SKY VIEW POINTE SUBDIVISION

APPLICATION NUMBER 10 DATE May 5, 2016

REQUEST Subdivision

DETAIL SITE PLAN

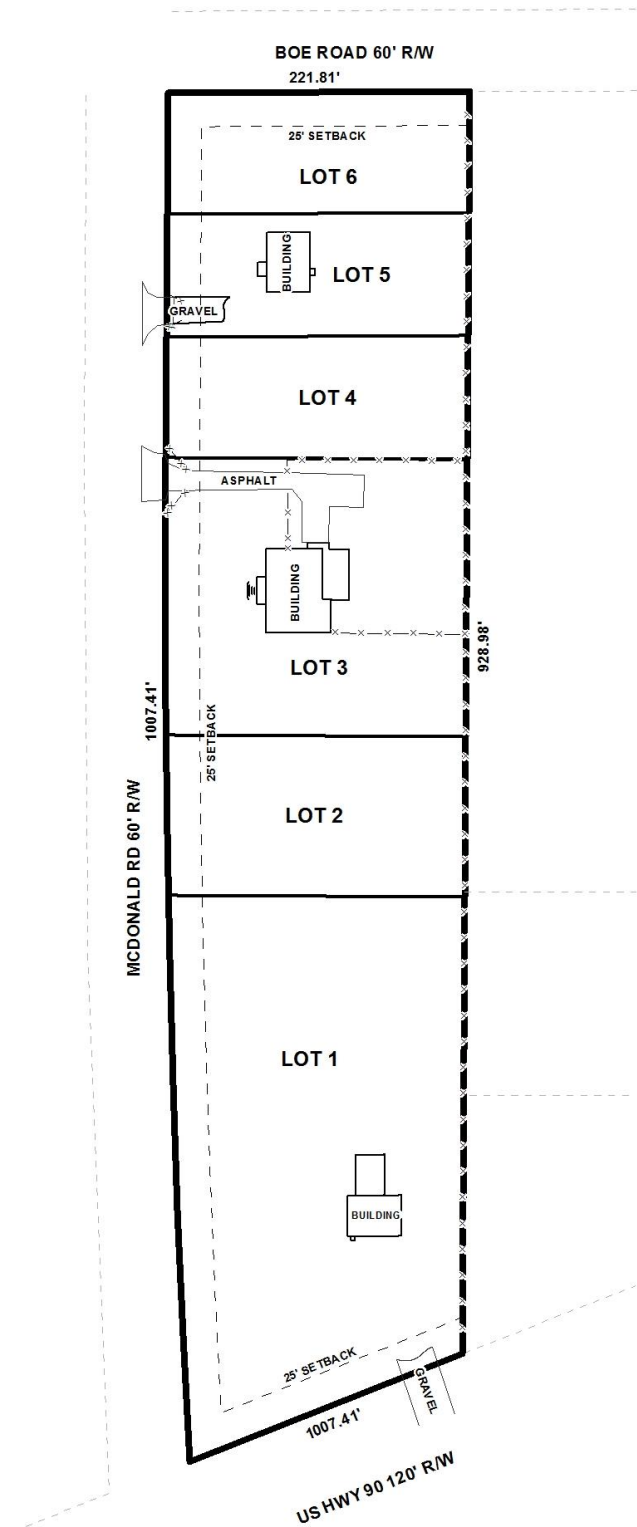
The site has frontage on U.S. Highway 90 to the South, a major street requiring a 250' right-of-way; McDonald Road to the West, a minor street without curb and gutter requiring a 60' right-of-way; and Boe Road to the North, a minor, unpaved street without curb and gutter, also requiring a 60' right-of-way. The existing right-of-way depicted along U.S. Highway 90 is 120', making dedication to provide 125' from the centerline necessary. Along McDonald Road and Boe Road the existing rights-of-way are depicted as 60', therefore no dedication should be required.

Dedication of the corner radii at U.S. Highway 90 and McDonald Road, as well as McDonald Road and Boe Road, are illustrated as required by Section V.D.6. of the Subdivision Regulations and should be retained on the Final Plat, if approved.

As a means of access management, a note should be required on the Final Plat stating that Lots 2, 3, 4, and 5 are limited to one curb cut each to McDonald Road; that Lot 1 is limited to a total of two curb cuts; and that Lot 6 is limited to one curb cut to McDonald Road and one curb cut to Boe Road, with their sizes, locations and designs to be approved by ALDOT (as necessary) and Mobile County Engineering, and conform to AASHTO standards.

The preliminary plat indicates a 25' building setback line along all frontages for each of the proposed lots, as required by Section V.D.9. of the Subdivision Regulations. If approved, this information should be retained on the Final Plat, adjusted for any required dedications.

Each lot meets the minimum size requirements of the Subdivision Regulations and is appropriately labeled on the preliminary plat. If approved, this information should be retained on the Final Plat, adjusted for any right-of-way dedications, or a table should be furnished on the Final Plat providing the same information.

- 1) dedication to provide 125' from the centerline of U.S. Highway 90;
- 2) placement of a note on the Final Plat stating that Lots 2, 3, 4, and 5 are limited to one curb cut each to McDonald Road; that Lot 1 is limited to a total of two curb cuts; and that Lot 6 is limited to one curb cut to McDonald Road and one curb cut to Boe Road, with their sizes, locations and designs to be approved by ALDOT (as necessary) and Mobile County Engineering, and conform to AASHTO standards.

- 3) retention of the building setback line for each lot on the Final Plat;
- 4) retention of the lot sizes in square feet and acres on the Final Plat, or the furnishing of a table on the Final Plat providing the same information, adjusted for dedication;
